ENGINEERING BULLETIN

July 9, 2003

SPRING SEAT CHANGE

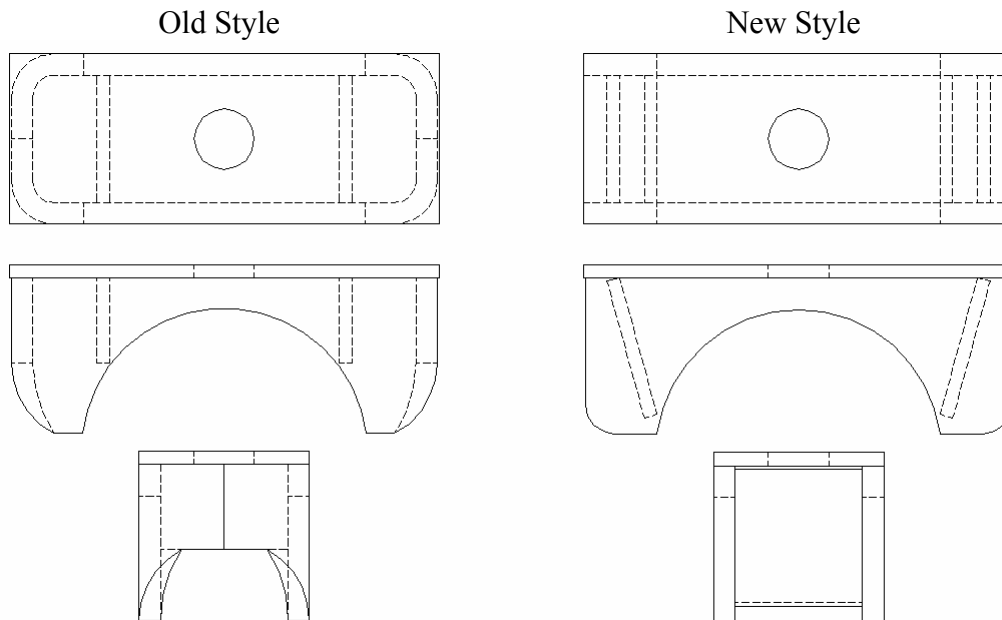
Hutchens Industries has created a new series of underslung / no-hop spring seats. These seats do not have a formed back. Instead, the side plates are straight and the internal tie plate serves as the ends of the seat. This matches the design of our standard spring seats with the radius rod attaching ears. Installation remains the same. The figures below illustrate the differences.
